18C Operator Interface Equipment Characterization

The information in this appendix of the reference ABWR DCD, including all subsections and figures, is incorporated by reference with the following departure and a supplement.

STD DEP T1 3.4-1 (Figure 18C-8)

Figure 18C-8 Overall Configuration of Operator Interface System

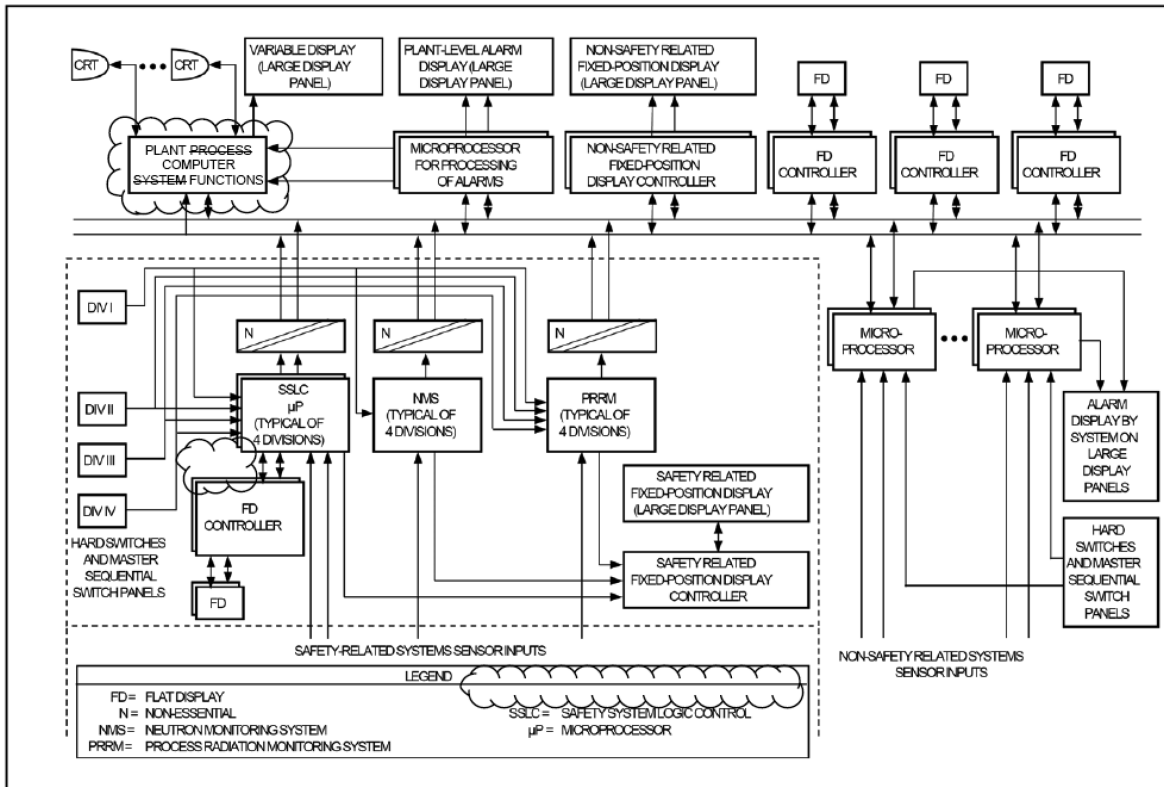
A characterization of the plant instrumentation and control systems architecture which supports the control room operator interface is illustrated in Figure 18C-8. As shown in Figure 18C-8, display and control capability for both safety-related and non-safety-related systems are driven by microprocessors which are independent of the redundant plant process computer functions. This assures the ability to safely shut down the plant in the unlikely event of computer failure. In the case of the safety-related systems, the microprocessors are divisionally dedicated and are each electrically isolated from the rest of the system.

The instrumentation and control systems architecture is not identical to the conceptual design described in Appendix 18C. The changes in the next paragraph reflect the architecture and configuration.

~~The plant wide, fiber optic Essential Multiplexing System (EMUX) provides the communications network for the system. This multiplexing system is actually a series of data acquisition and control networks, separate networks being provided for safety related and non safety related plant systems.~~ The data communication function includes both safety-related and non-safety-related communication performed by separate networks as described in Section 7.9S.
